ADDENDUM NO. 1

BDVWA WATER SYSTEM IMPROVEMENTS AND CONSOLIDATION PROJECTS

October 7, 2026

SHEET AMENDMENTS

DRAWING NUMBER
C207
7 / 32

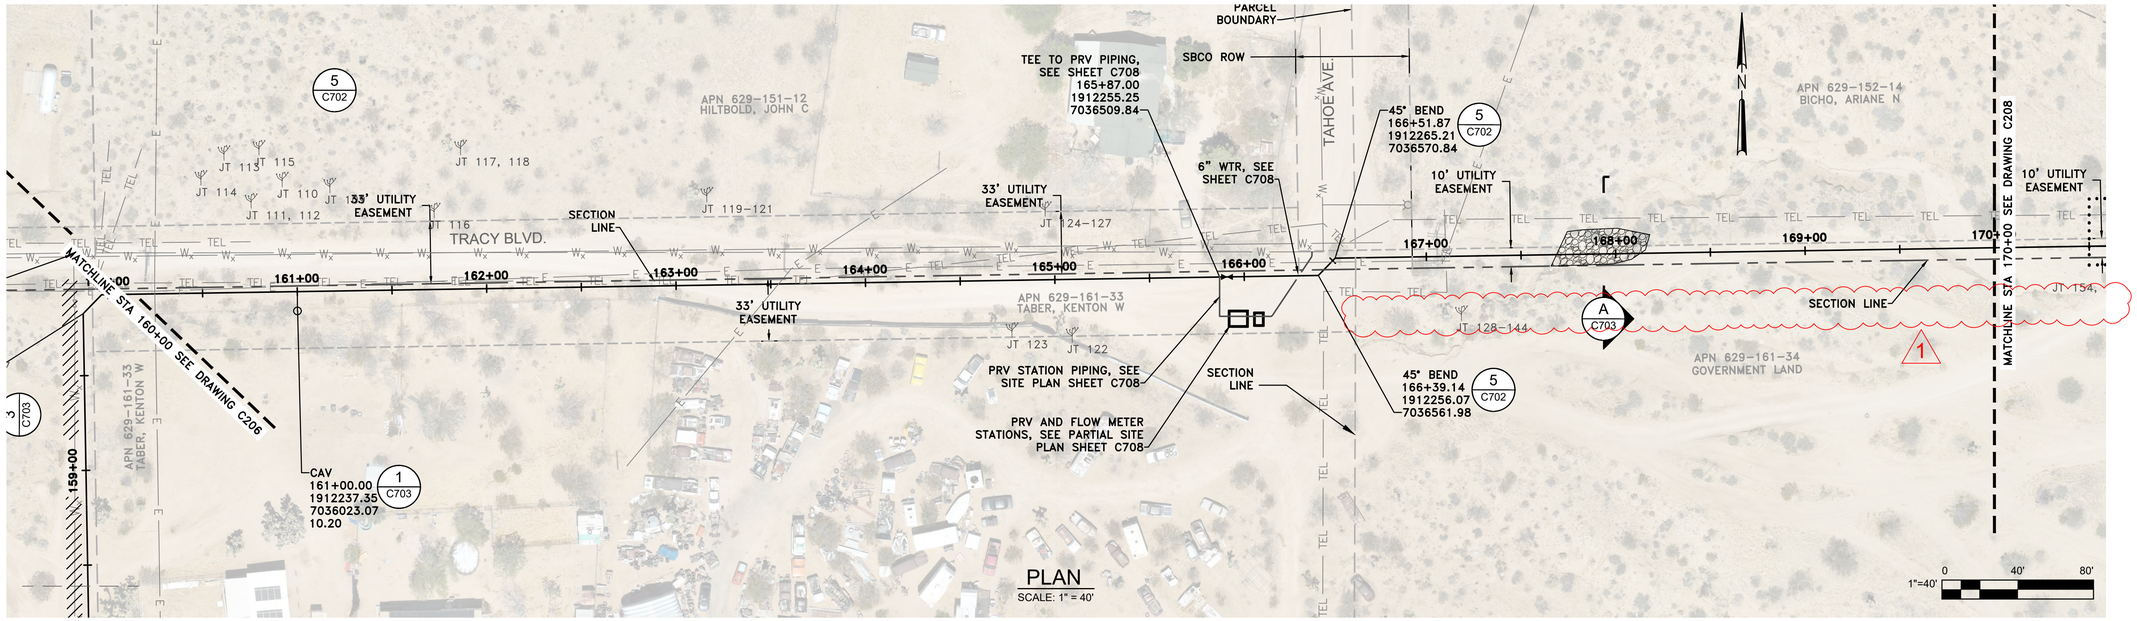
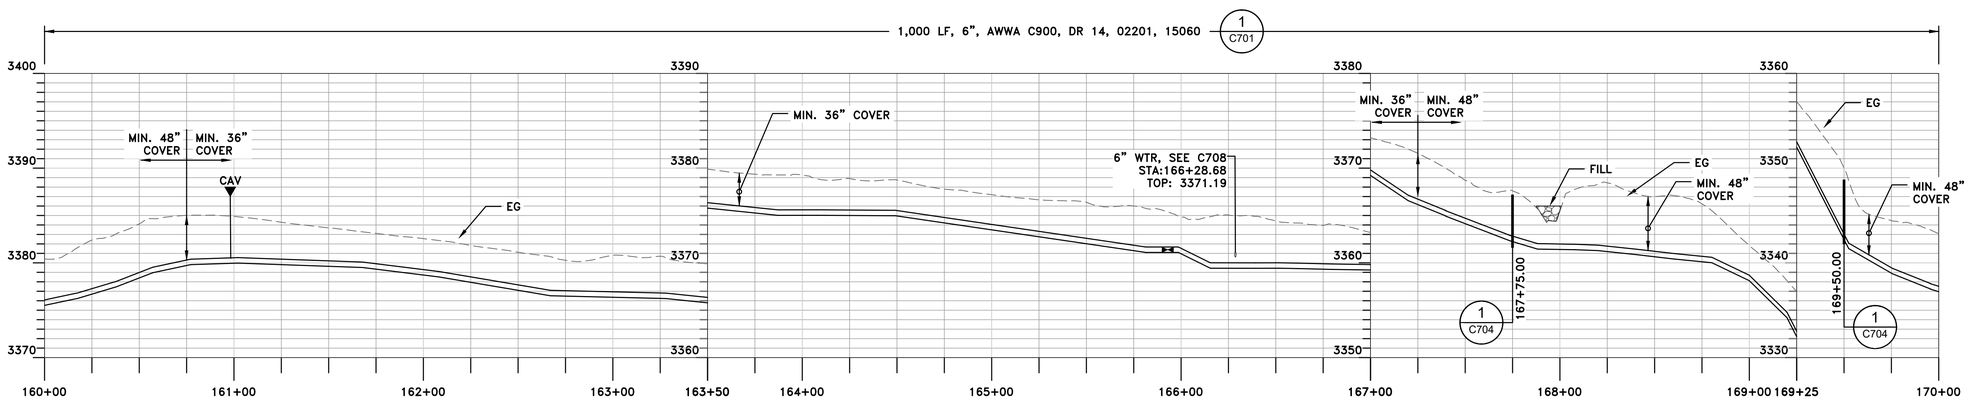
Item No.	Drawing No.	Description
1	**Vol. 1 C207**	Delete easement line from APN 629-161-34
2	**Vol. 1 C208**	Delete easement line from APN 629-161-34
3	**Vol. 1 C209**	Delete easement line from APN 629-161-34
